AMENDMENTS TO THE DRAWINGS

REMARKS

Fig. 3

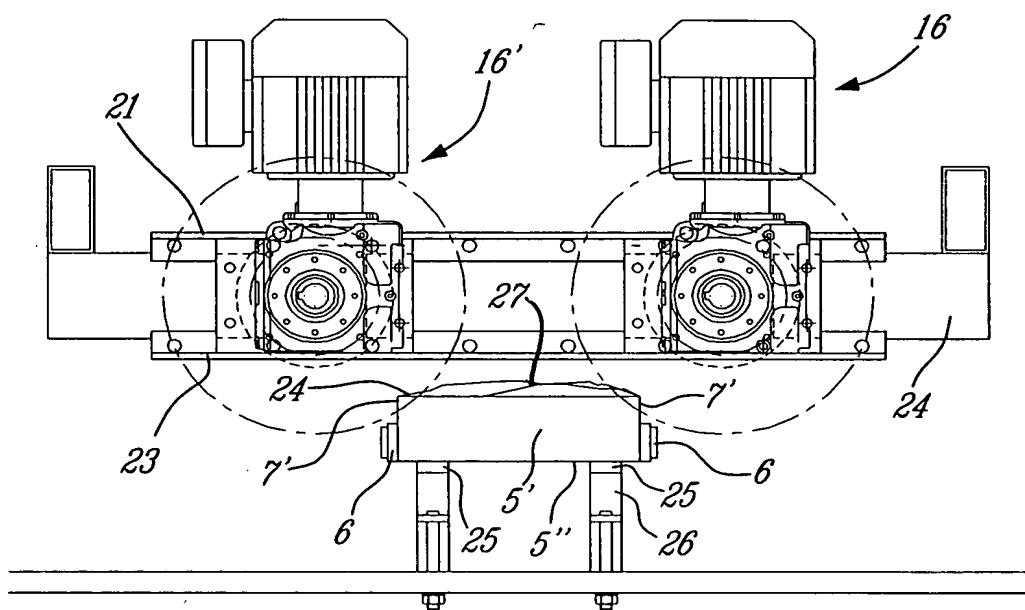
The attached sheets of drawings include changes to Figures 3, 4 and 9. These sheets replace the original sheets. Reference character 27 has been added to Figures 3 and 4. Reference character 53 has been added to Figure 9 and former reference character 53 has been changed to character 50.
